Metro Outer Development Assessment Panel Agenda

- 3.1 Lot 89 (No.11) Moores Road, Pinjarra – Proposed Veterinary Centre –
DAP/25/02911

Part B – Item 3.1 – LOT NO. 89 (NO. 11) MOORES ROAD, PINJARRA – PROPOSED VETERINARY CENTRE

Form 1 – Responsible Authority Report (Regulation 12)

4. Draft District Structure Plan Map under Draft PDSP.

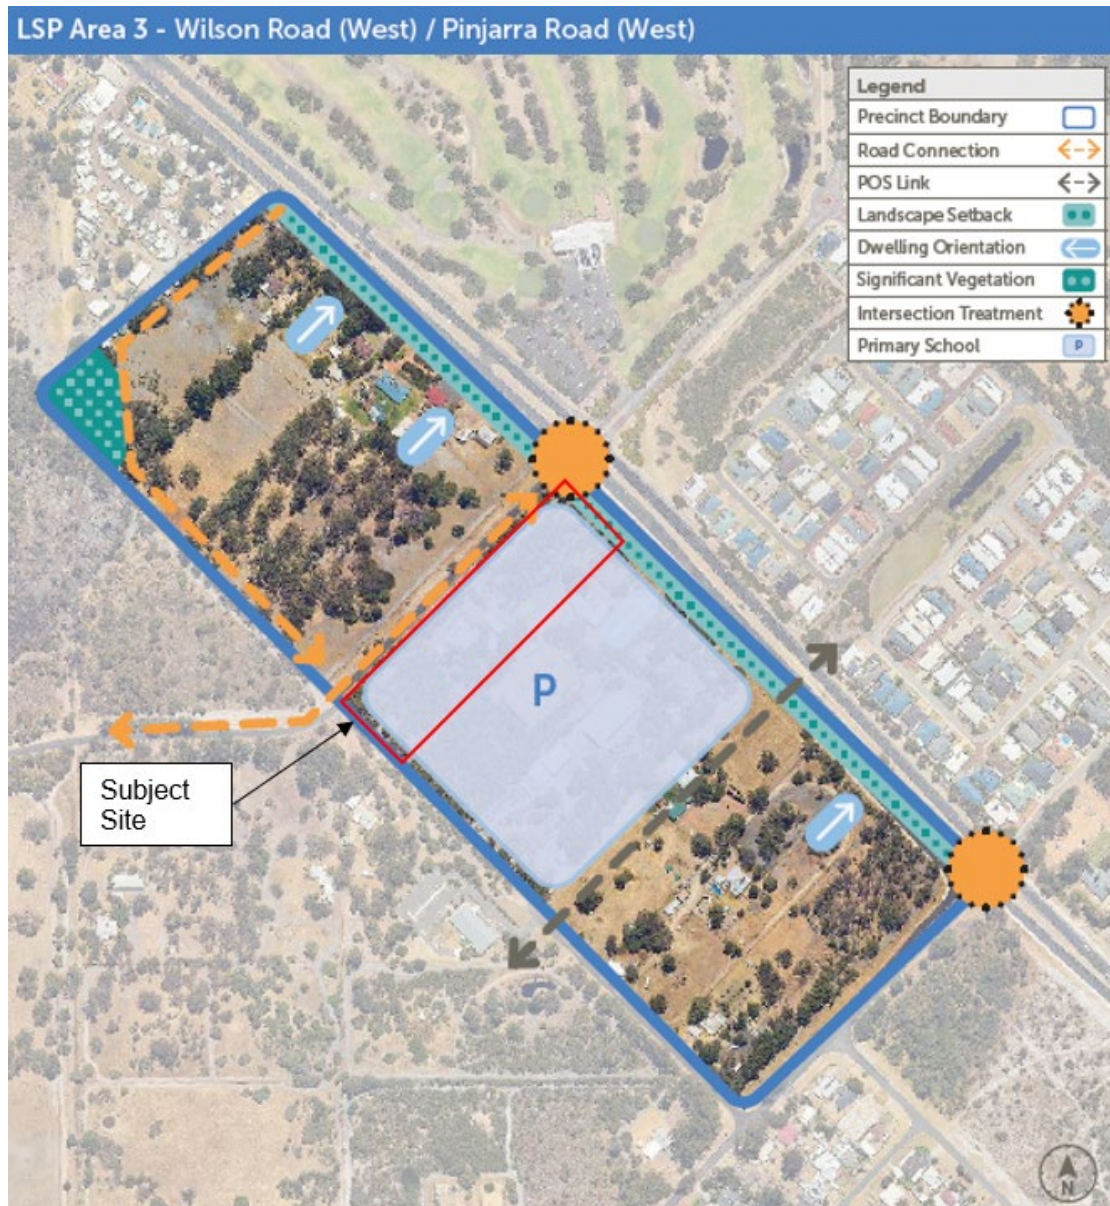
The subject site has been identified within the draft PDSP as a future Primary School site (**Figures 4, 5 & 6**). The Department of Education (DoE) originally raised concerns with the proposed location as Pinjarra Road is a Primary Regional Road and *operational Policy 2.4 Planning for School Sites* and *Liveable Neighbourhoods* do not recommend schools in such locations due to traffic safety. After receiving the advice, the Shire undertook further investigations which concluded that:

The Shire, however, notes that the acoustic report fails to consider the sites location within a future higher density residential precinct under the PDSP (**Figure 4**). If the adjoining site at Lot 88 (1774) Pinjarra Road, Pinjarra was to be developed to a R40 standard this would introduce additional dwellings directly adjacent to the site. This represents the potential for significant future land use conflicts that may fetter the ability to deliver urban land and will impact the amenity of future residents.
